SUBJECT: MEETING NOTIFICATION AND TRANSMITTAL OF TENTATIVE AGENDA

MAG Standard Specifications and Details Committee
TENTATIVE AGENDA
June 1, 2016

MEETING MINUTES FROM THE
MARICOPA ASSOCIATION OF GOVERNMENTS
STANDARD SPECIFICATIONS AND DETAILS COMMITTEE

2016 PROPOSED REVISIONS TO MAG SPECIFICATIONS AND DETAILS

391-2

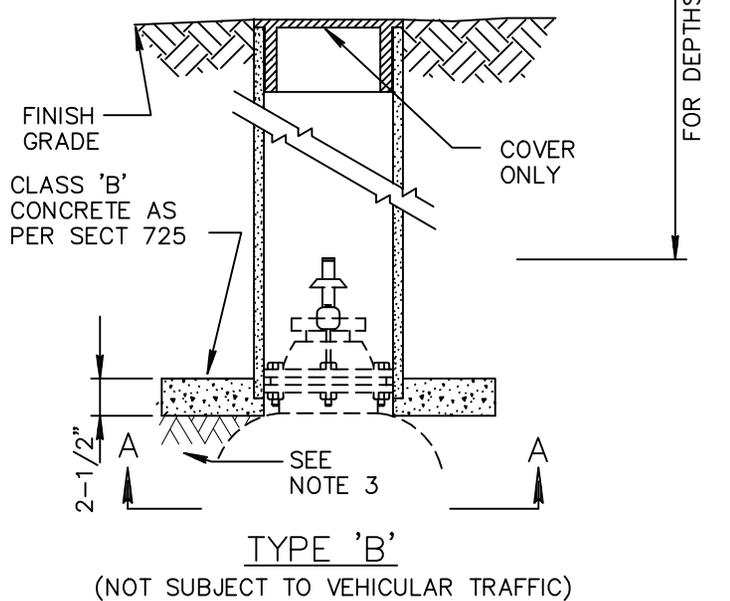
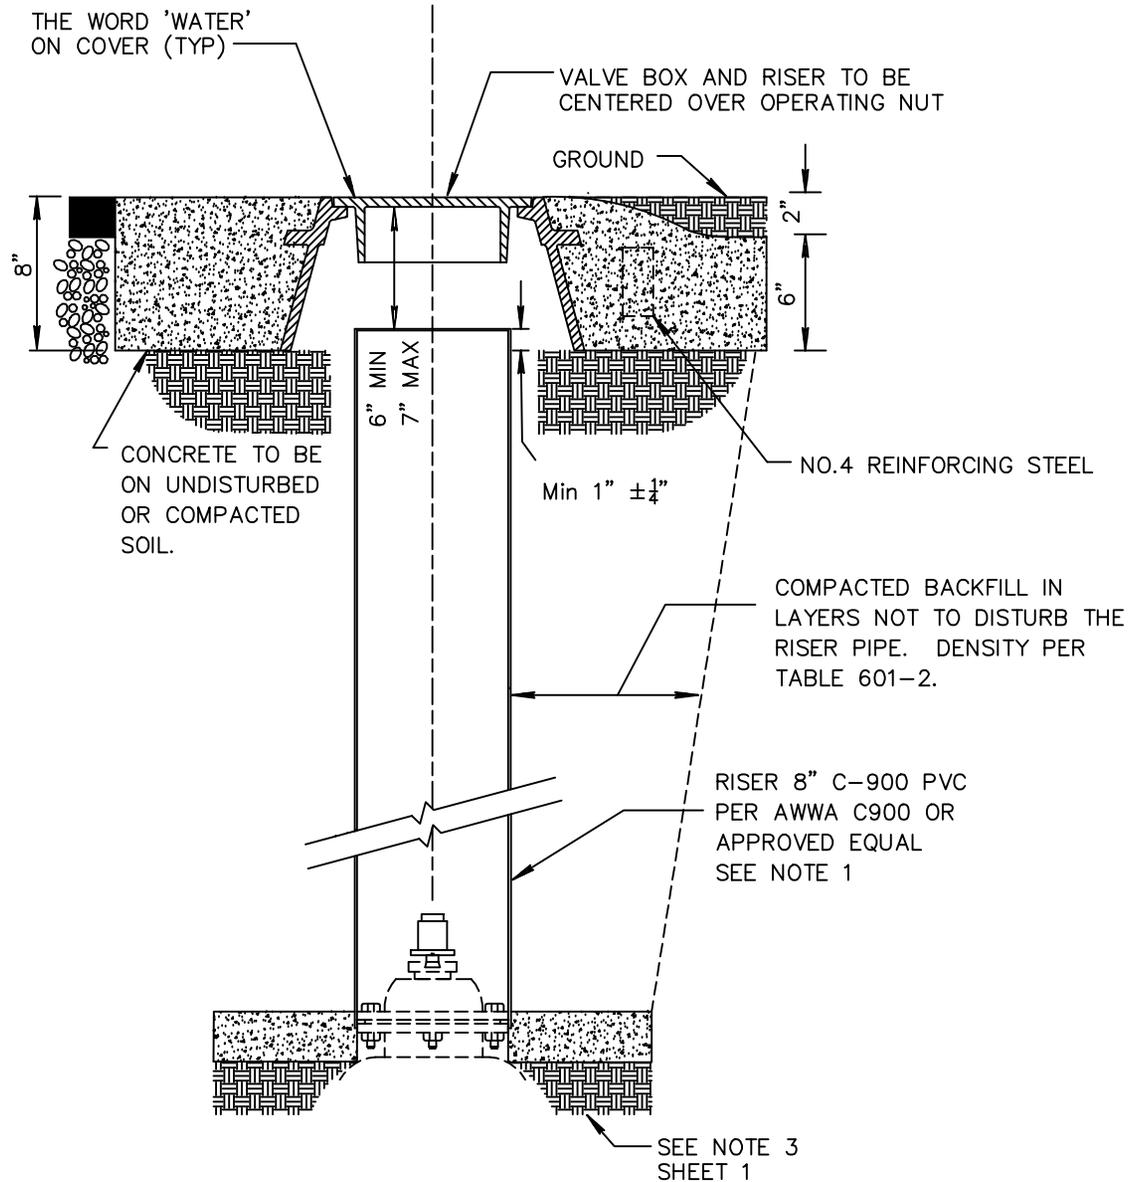
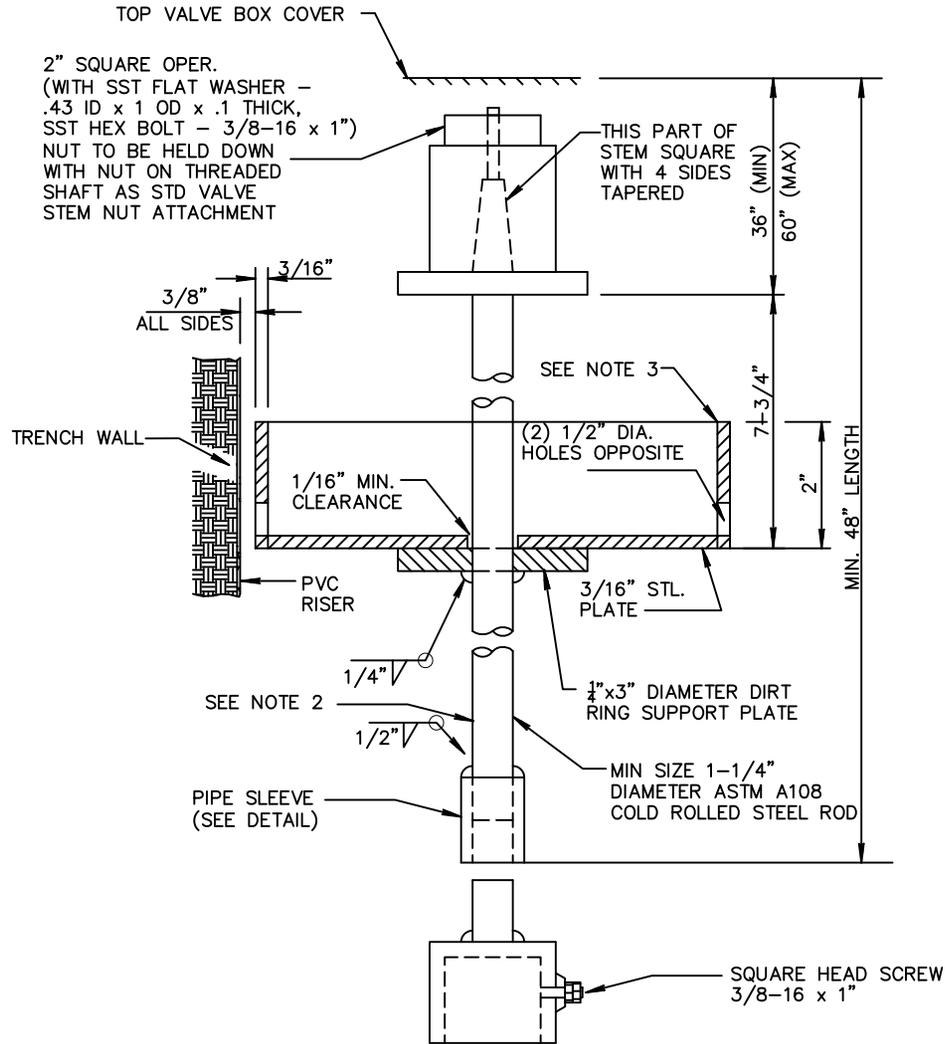
Craig Sharp introduced a new case to separate valve box installation and grade adjustment details. This included revising Detail 391-2 to remove the valve stem extension drawing, and creating a new Detail 393 for the valve stem extension. The new extension drawing would allow adjustable lengths to be more easily manufactured.

There were comments about the minimum dimensions for the depth shown on the new Detail 393. Based on other dimensions they would need to be larger. Paul Nebeker asked when extensions were required. Mr. Sharp said currently valves under 5' do not need extensions and this was not changed. Mr. Nebeker said there are problems if they are too shallow because the key becomes difficult to turn if it is up too high. Rob Godwin suggested extending the depth that doesn't require an extension to 6' instead of 5'. Paul Nebeker said in other parts of the country extensions are not allowed. Mr. Sharp said he could adjust the detail to show a range of 36"-60". Mr. Nebeker suggested reviewing agency requirements and said valves are often activated automatically. Craig Sharp said representatives from Oldcastle brought in a sample valve extension for members to see.

Lace Webb of Mesa said Details 391-1 and 391-2 would also need to be adjusted if the maximum depth is increased. Mr. Sharp said they also need to be updated to reference the new Detail 393.

Rob Godwin suggested adding a specification to determine what it means to be "plumb." What tolerance is allowed? Mr. Nebeker said he has had issues with the dirt ring binding up and asked about the tolerances. Mr. Sharp said Note 4 allows the dirt ring to float freely above the plate it rests on. There were suggestions to note these items on the drawing.

Revisions: To Detail 391-2 to remove Valve Stem extension drawing.

Create new Detail 393 for the valve stem extension.

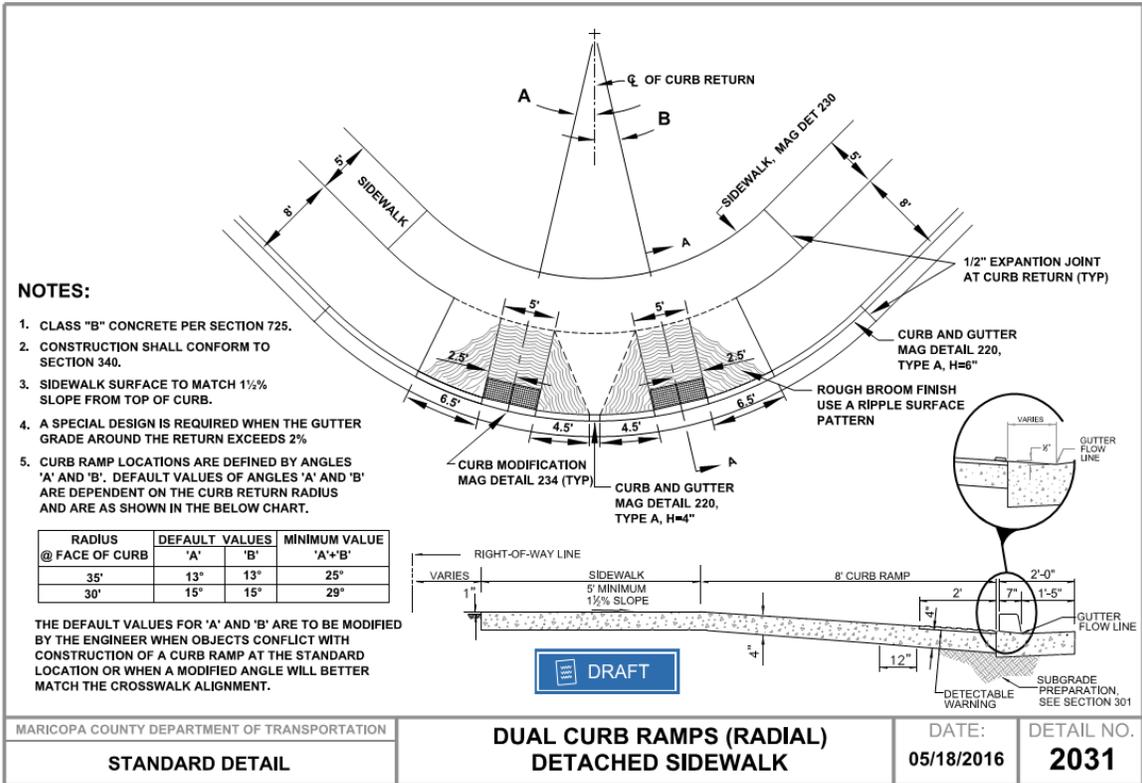
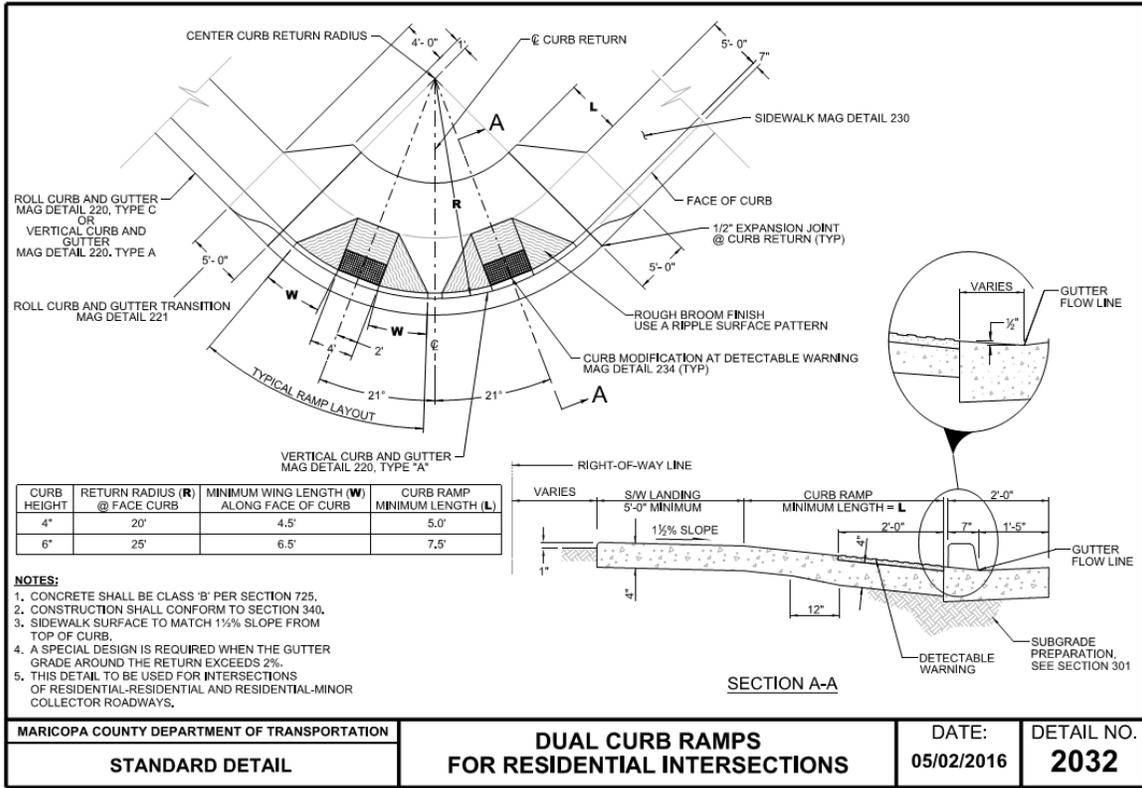
Identify the curbing within the curb return as VERTICAL CURB AND GUTTER DETAIL 220, TYPE A.

Section A-A Details Delete the maximum allowable slopes shown in parentheses: S/W LANDING (2% MAX) and CURB RAMP (8.33% MAX) – Section 340.3.9 Tolerance identifies the maximum values allowed. Placing those values on the standard details makes the desired slopes appear to be optional since they are allowed to vary up to the listed maximum values.

The gutter counter slope of 5.0% MAX is unnecessary and should be deleted since Detail 220 Vertical Curb and Gutter, Type A is referenced and the detail is compliant with the ADA requirement. How is the 5.0% MAX notation expected to change or impact the Contractor's work?

Section A-A Details for directional ramps: Delete at the bottom of the ramps both the 1.5% SLOPE and (2% MAX) – The slope between the detectable warnings and gutter flowline will not be constant and will vary across the entire width.

Plan View: Delete the ramp and landing cross slope call-out 1.5% CROSS SLOPE (2% MAX), the callout incorrectly suggests that the indicated areas should have 1.5% cross slope. No cross slope is required for the radial curb ramps and Section 340.3.9 Tolerance identifies the maximum allowed value as 2%.
